MANUAL HARD COPY DISTRIBUTION  
DOCUMENT TRANSMITTAL 2019-13196

TRM2 - TECHNICAL REQUIREMENTS MANUAL UNIT 2

ID: TEXT 3.2.1  
ADD: REV: 17

**Susquehanna SES  
Unit 2 Cycle 20**

MCPR OPERATING LIMIT VERSUS TOTAL CORE FLOW  
 MAIN TURBINE BYPASS / EOC-RPT / BACKUP PRESSURE REGULATOR OPERABLE  
 TWO LOOP OPERATION (BOC TO EOC)  
 FIGURE 5.2-1

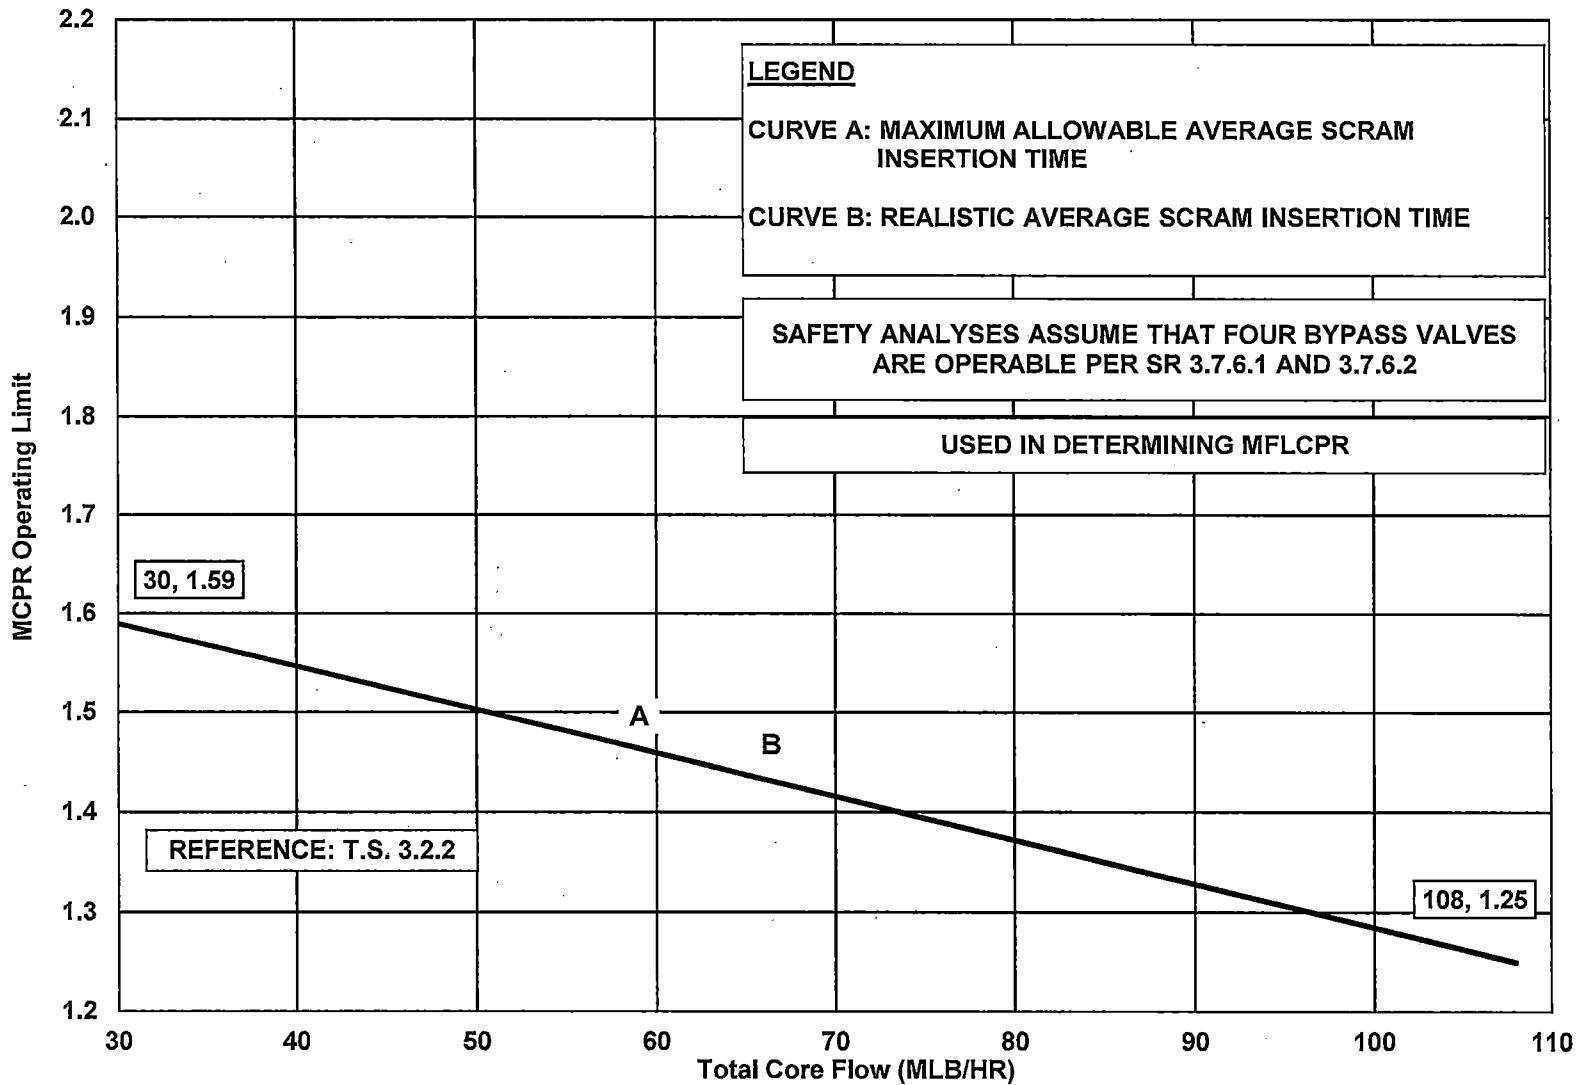
2	ALL	<p>The U2C20 COLR is revised to include licensing analyses results for the full cycle of U2C20 operation.</p> <p>Changes are made to the following figures: 5.2-1 to 5.2-10, 6.2-3, 6.2-5, 6.2-7, 6.2-9, and 8.2-2 to 8.2-11. Changes to the thermal limits are limited to the following figures: 5.2-4, 5.2-8, 6.2-3, 6.2-5, 6.2-7, 6.2-9, 8.2-5, and 8.2-9. Only the captions were changed for the remaining figures (5.2-1 to 5.2-3, 5.2-5 to 5.2-7, 5.2-9, 5.2-10, 8.2-2 to 8.2-4, 8.2-6 to 8.2-8, 8.2-10, and 8.2-11).</p> <p>Revision 2 of the Unit 2 Cycle 20 COLR is valid for operation from BOC to EOC.</p>
